Application Number 10/714,801  
Amendment dated July 24, 2006  
Reply to Office Action of May 22, 2006

Amendments to the Drawings:

FIG. 2

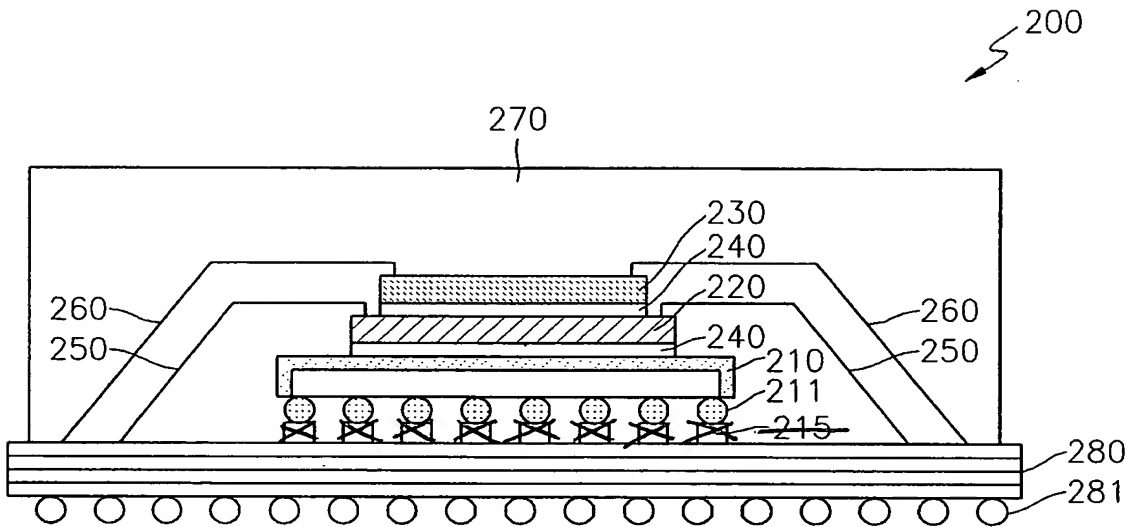
The attached sheets of drawings include changes to Figures 2, 4, 6, and 8. The sheets, which includes Figures 2, 4, 6, and 8, replace the drawings presented in the previous Amendment dated February 10, 2006. Specifically, Figure 2 is amended to remove solder bumps 215. In addition, Figure 4 is amended to remove solder bumps 415. In addition, Figure 6 is amended to remove solder bumps 615. In addition, Figure 8 is amended to remove solder bumps 815.
